NMOCD approves the delineation workplan for 1RP-4500 with one condition:

Re: Proposed Delineation Workplan

Trunk M Release (1RP-4500)

Figure 2
Site Details & Proposed
Investigation Trench Map
ETC Field Services, LLC
Trunk M
Lea County, NM

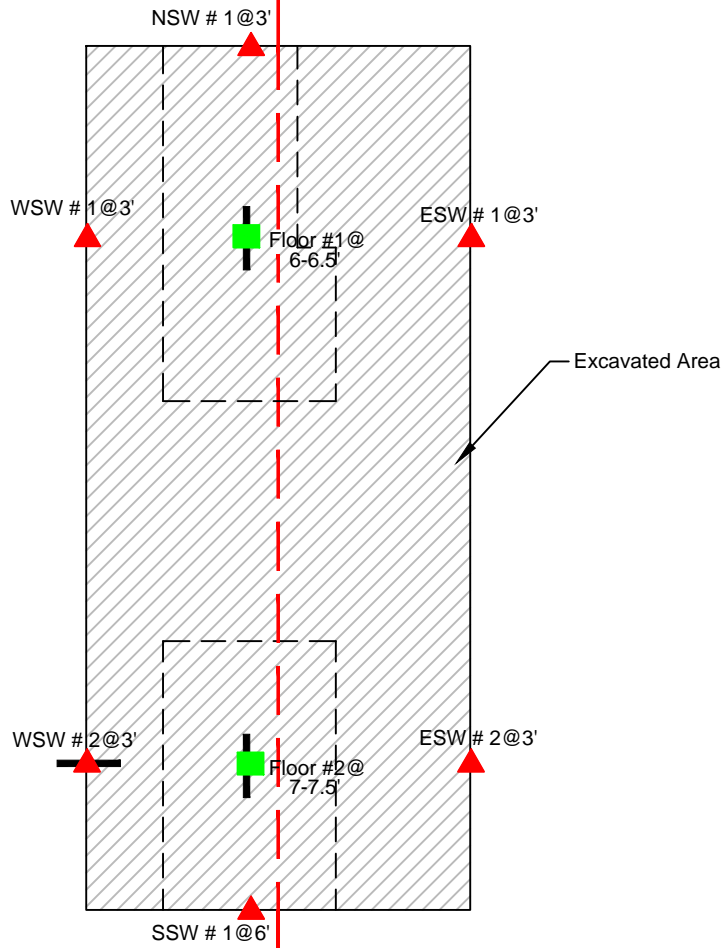
Vertical delineation is considered completed when BTEX, TPH, and 600 mg/kg chloride levels are obtained and maintained for an additional minimum of 5 ft. further.
